Athleta - Portland, ME - Louver Exemption

As we discussed over the phone a few days ago, I am working on a retail store project going up at 152 Middle St. in Portland, ME (which already went out for Permit). For this location, at the start of the design we reached out to the historical building department regarding fresh air and relief/exhaust locations and they strongly urged us to not put any louvers in the walls, but rather to locate the louvers in the windows located in the alleyway. While out on the survey, we did not find any ductwork inside the space that connected to an outside air intake or relief/exhaust air system. For that reason, we are showing a fresh air intake and relief/exhaust louver in the alleyway windows in accordance with the historical department suggestion. However, the relief/toilet exhaust louver is within 10 feet of the operable windows above (which are residential spaces). Per our call, could you confirm that we can have the relief air/toilet exhaust louver within 10 feet away from the operable windows above as it appears there are no other means to exhaust/relieve the space?

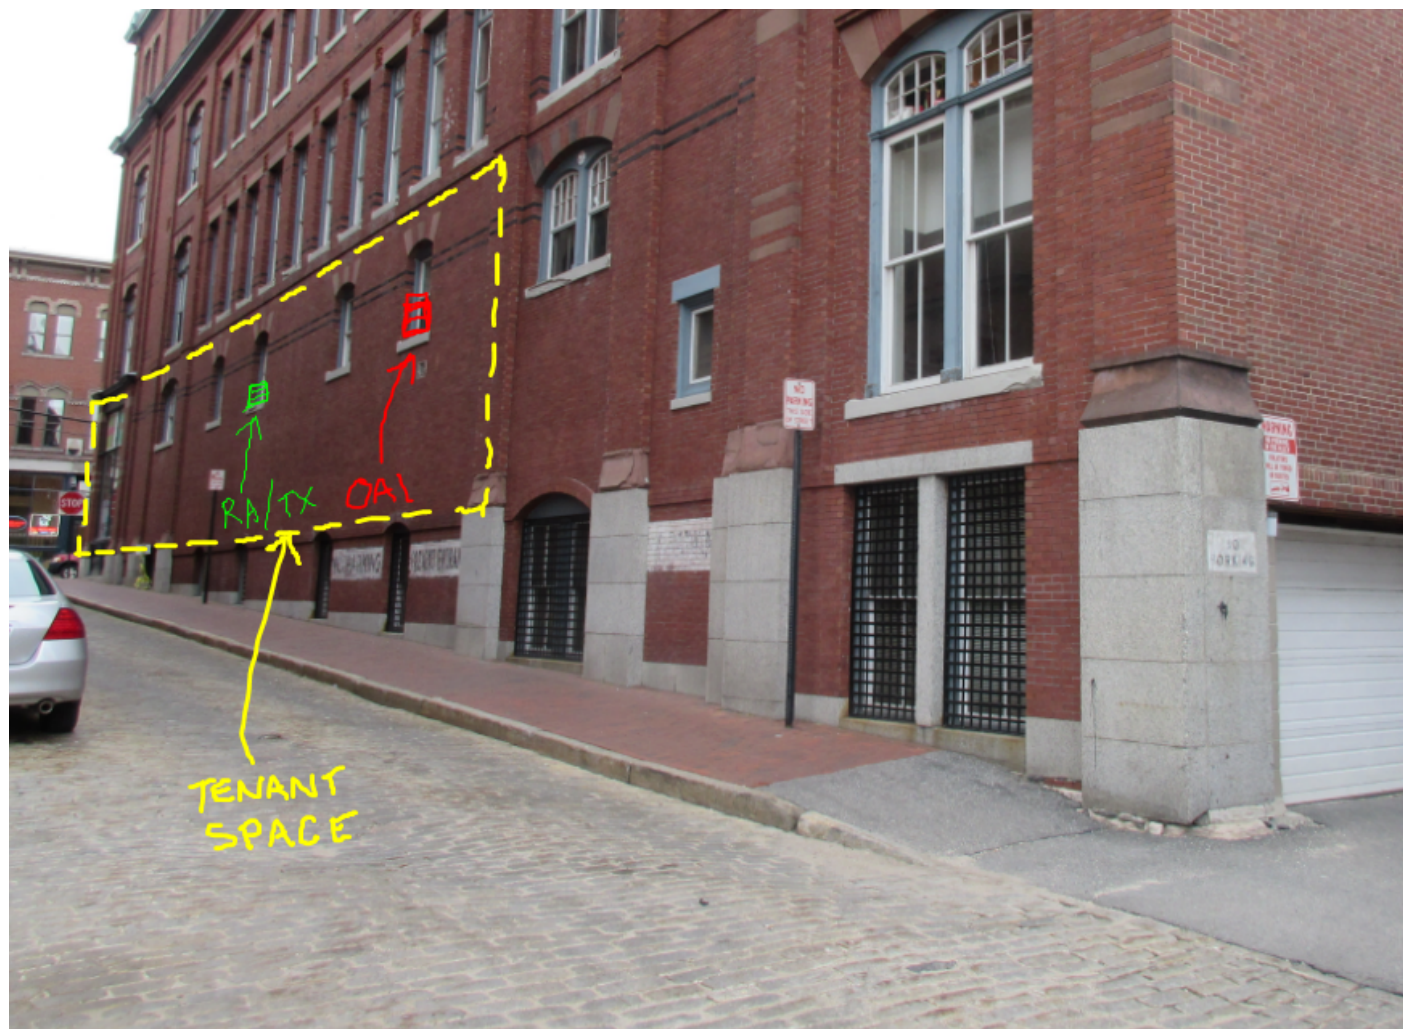
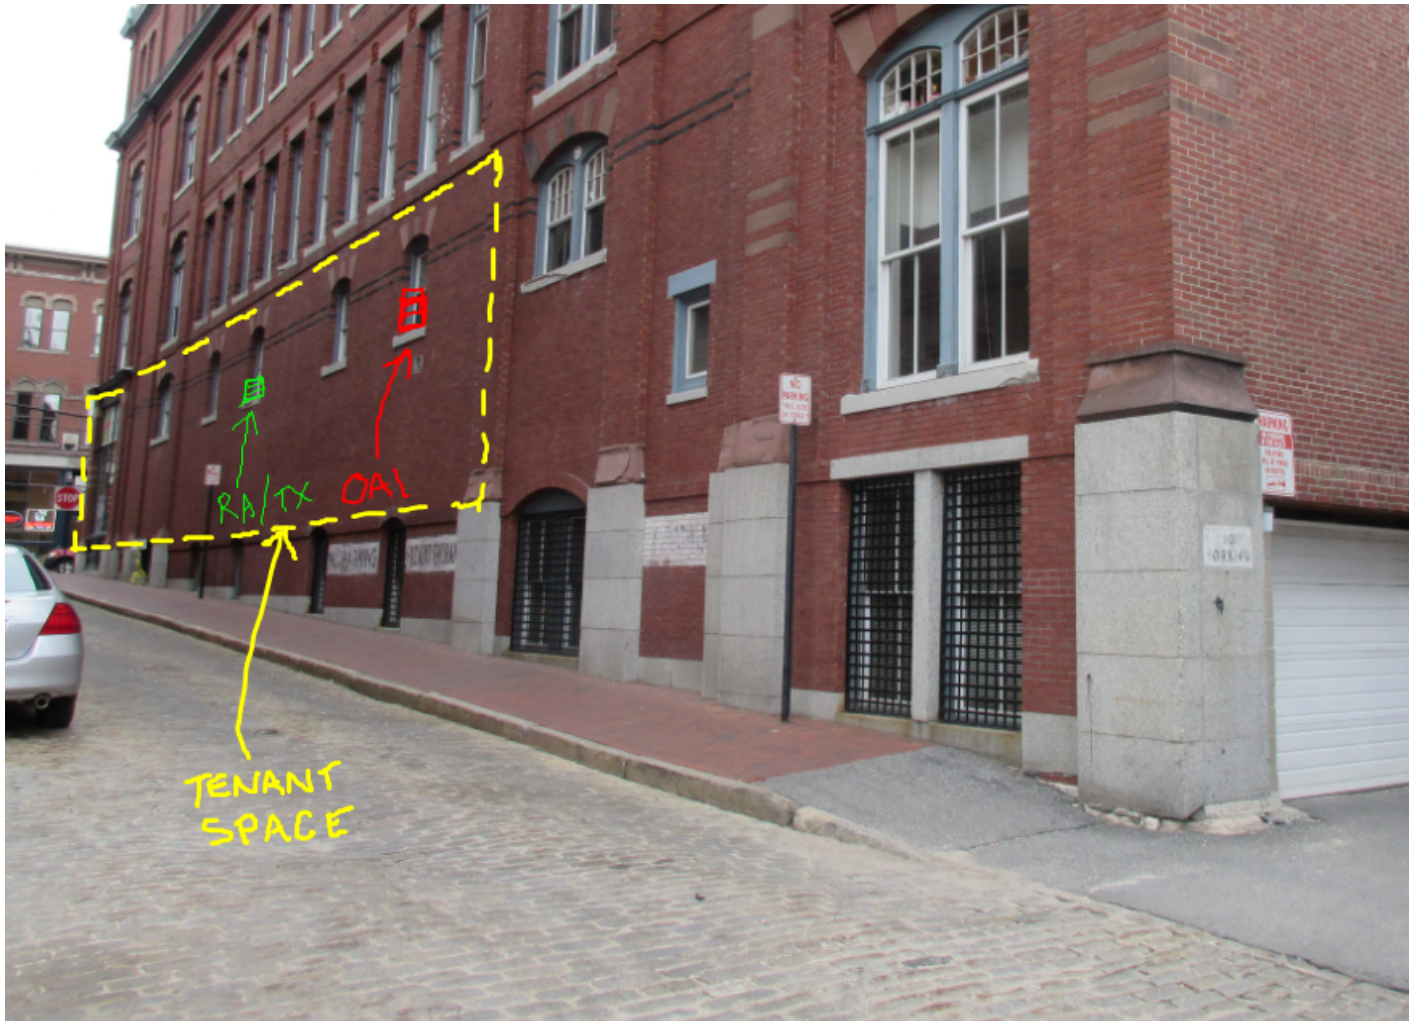
I've attached a photo of the alleyway area in question, please see attached. In the image below, you can see a marked-up image of the space showing the outside air intake, and relief/exhaust louver locations in respect to the operable windows.

Thank you for sending the detail of these louvers. Can you give me an estimate on the distance from the top of the bath exhaust louver to the window opening above?

From what we can judge by our onsite measurements of the window and the photos, there is about 7'-8' between the middle of the window where the louver will be located and the bottom of the operable window above. The louver will be located in the bottom half of the window, so the top of the louver will be located in the middle of the existing window.

Thanks Nick, this will be allowed to be installed as proposed. This seems to be somewhat of a minor issue, albeit not 100% as prescribed by the code. Hopefully this will not be a nuisance, however, if our office receives complaints it may need to be addressed.
